LINCOLN CENTRAL SCHOOL CLASSROOM ADDITION

Updated 05/09/2025

Questions we have received with responses.

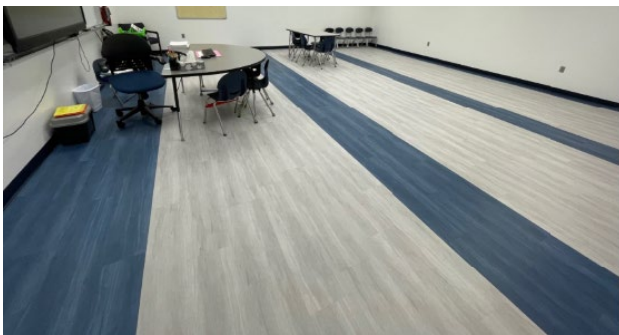
11. 6. Specification Section 096500 calls for two colors of LVT in a 70% and 40% mixture. This is 110%. Please clarify. **It will be 100%, we will make final determination with submittal, the selected colors are quick ship. Will look like:**
